ND-16-0328
10 CFR 50.90
10 CFR 52.63

Southern Nuclear Operating Company
Vogtle Electric Generating Plant Units 3 and 4
Request for License Amendment and Exemption:
Passive Core Cooling System (PXS) Design Changes to Address Potential Gas Intrusion
(LAR-16-004)

**Passive Core Cooling System (PXS) Design Changes to Address Potential Gas Intrusion
(LAR-16-004)**

UFSAR Figure 3B-14 Bounding Analysis Curve for 8" CMT Cold Leg Balance Line and Vent, DVI Cold Trap to RV

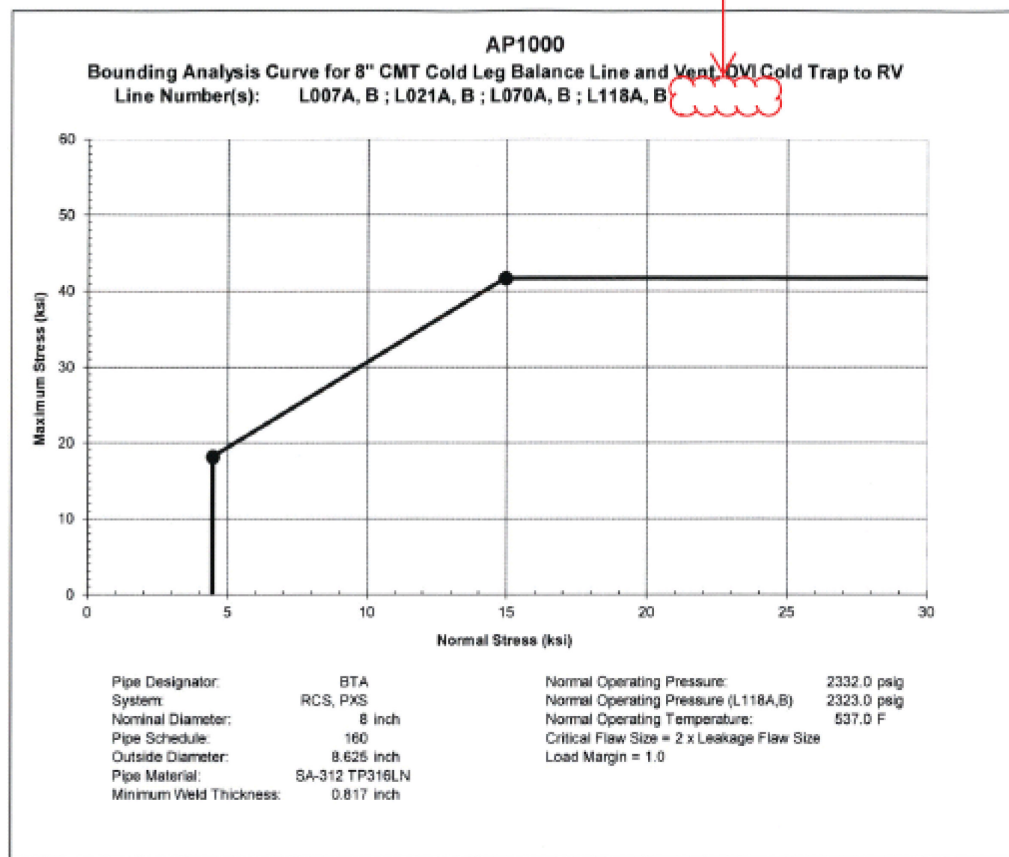
- Move PXS piping lines PXS-L125A and PXS-L125B from Figure 3B-14 to Figure 3B-15; and

Revise Figure as shown with **L125A, B** deleted from table heading

UFSAR Figure 3B-15 Bounding Analysis Curve for 8" CMT, DVI IWRST (Various Sections)

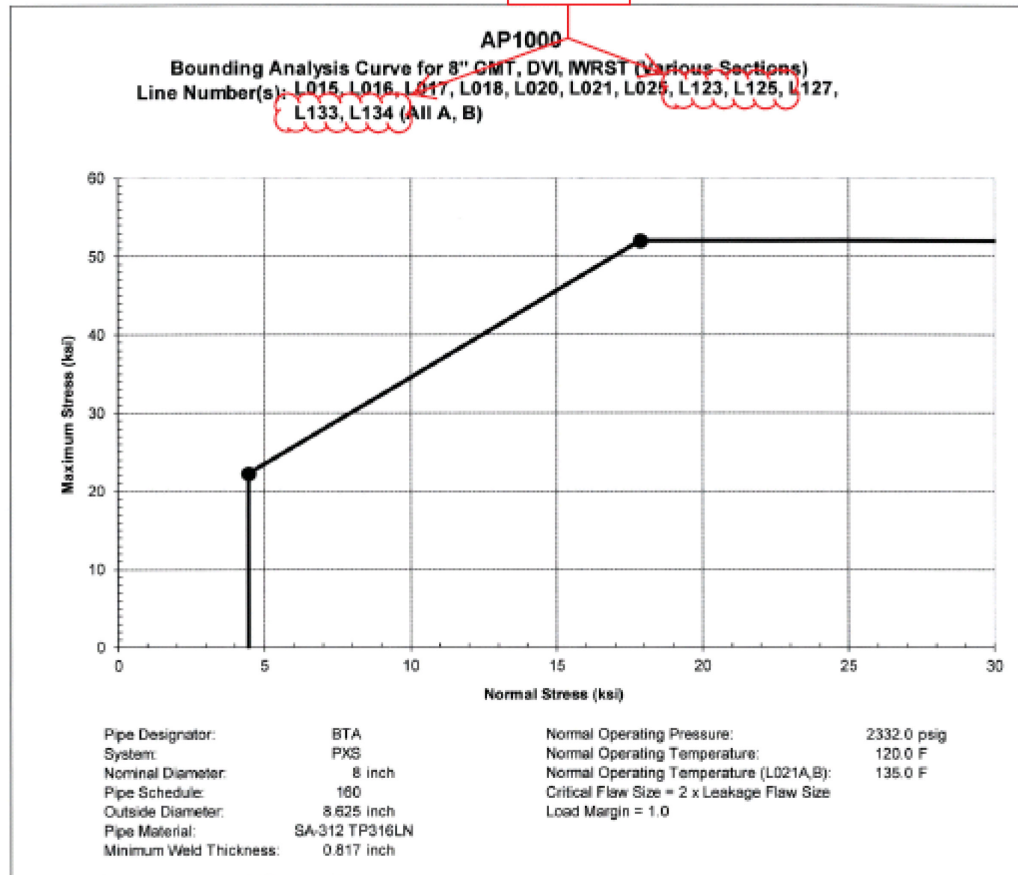
- Add PXS piping lines PXS-L123A, PXS-L123B, PXS-L133A, PXS-L133B, PXS-L134A, and PXS-L134B to Figure 3B-15.
- c) UFSAR Figure 3E-4 Sheet 2 is revised to:

Revise Figure as shown below: [Add L123, L125, L133, L134 to Line Numbers](#)
